Origination Form
Proposed Revisions to a Standard Plans Index

Originator:	Turley, Joshua	Index Number:	455-030
Date:	5/15/2025	Sheet Number(s):	Sheet 1
E-mail:	Joshua.Turley@dot.state.fl.us	Index Title:	30" SQUARE PRESTRESSED CONCRETE PILE

ELEVATION

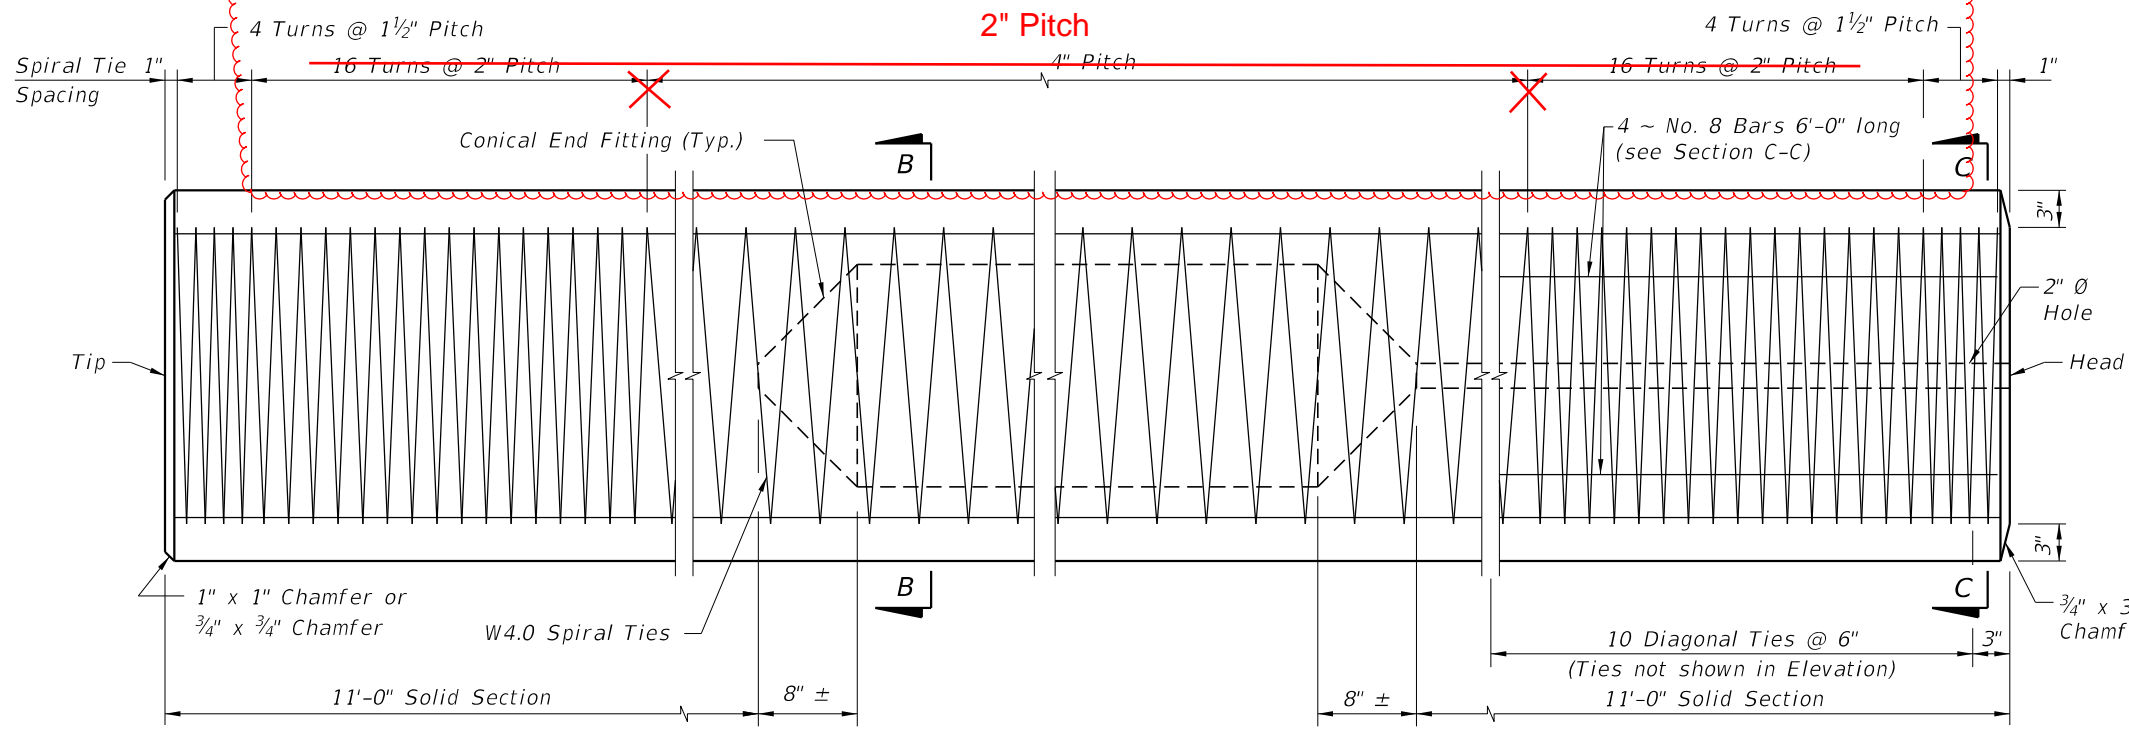
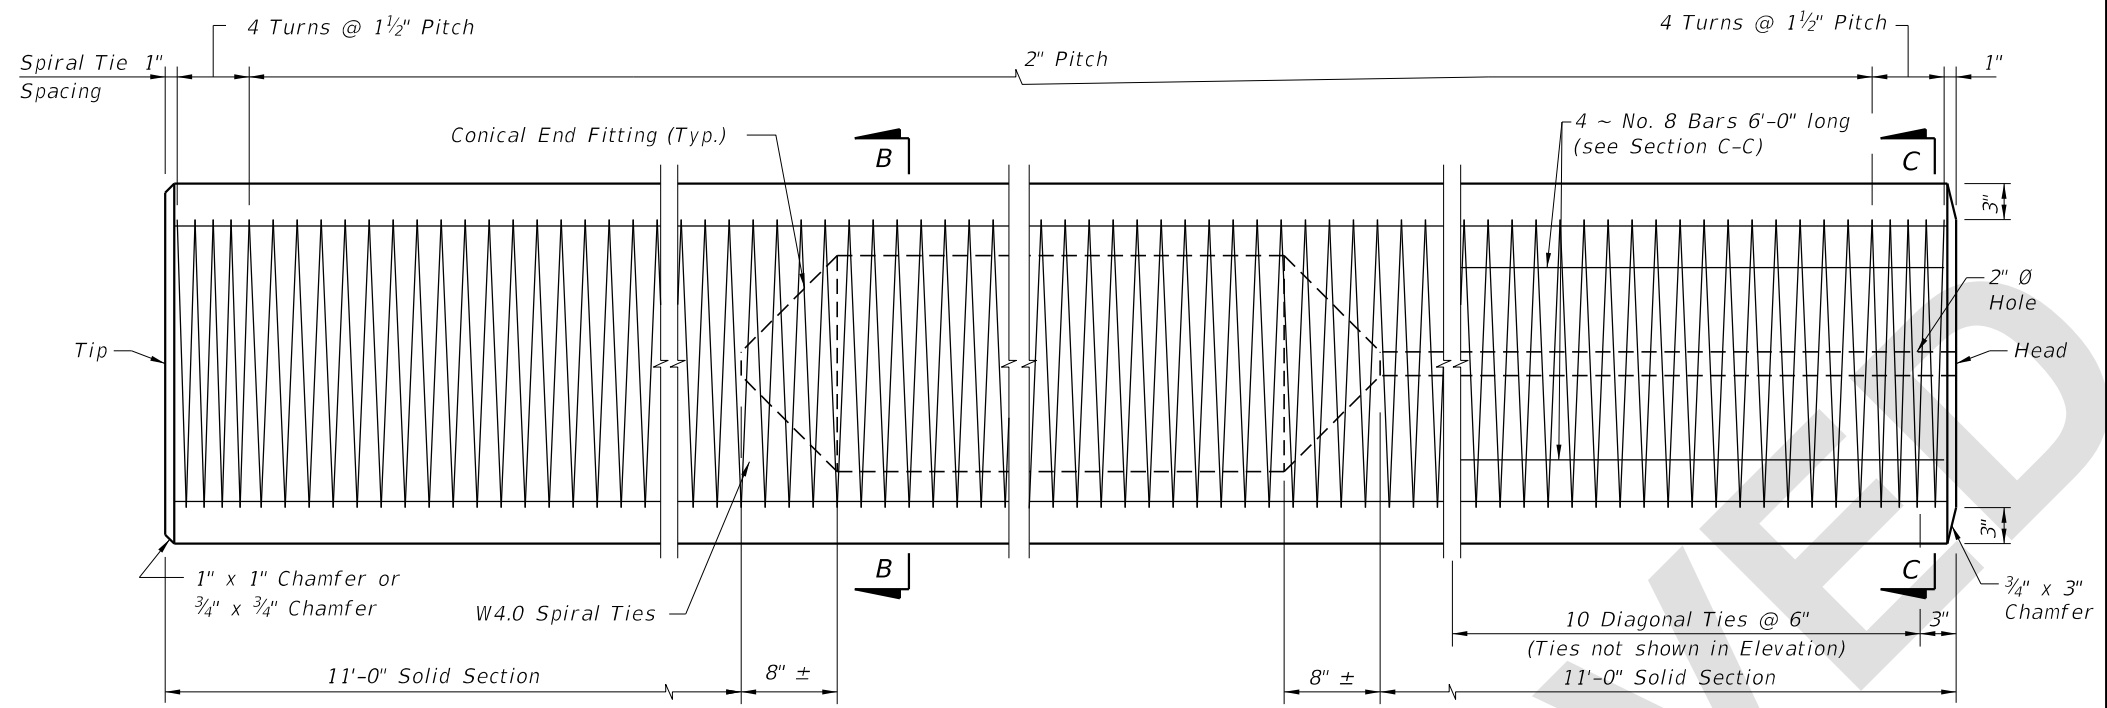
Sheet 1: Changed pitch spacing for the spiral ties; Changed SECTION D-D note "See unplanned reinforced CIP pile splice or non-drivable unplanned reinforced precast pile splice detail".

Vertical cracking has been observed in hollow core prestressed concrete piles, including 30-in. voided square HMC and conventional piles, and 60-in. hollow cylindrical piles, during installation and service. To address cracks frequently occur within the 4" stirrup pitch zone, a reduction in stirrup pitch to 2" is proposed to help mitigate cracking in these areas.

SECTION D-D

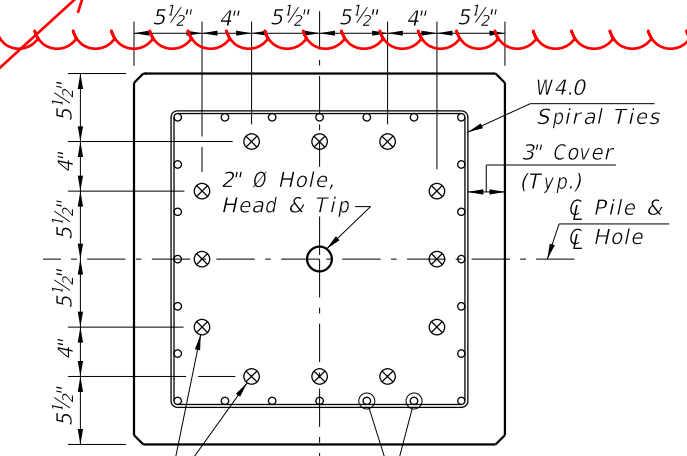
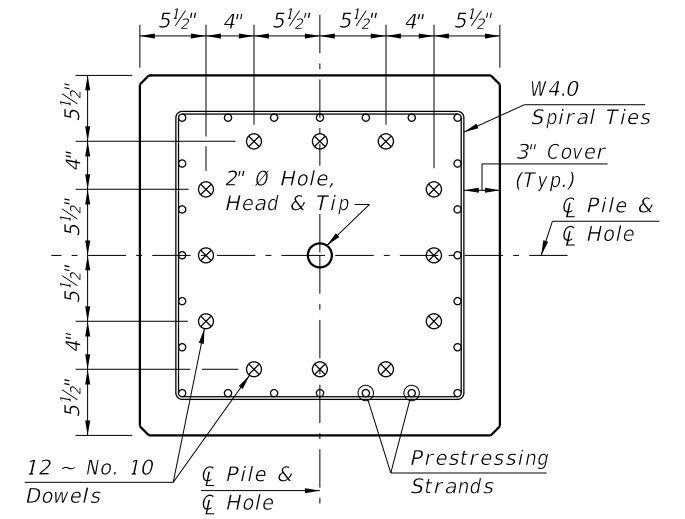
CHANGED:
 See Unplanned Reinforced CIP Pile Splice or Non-Drivable Unplanned Reinforced Precast Pile Splice Detail

SECTION D-D
(See Unplanned Reinforced CIP Pile Splice or Non-Drivable Unplanned Reinforced Precast Pile Splice Detail)
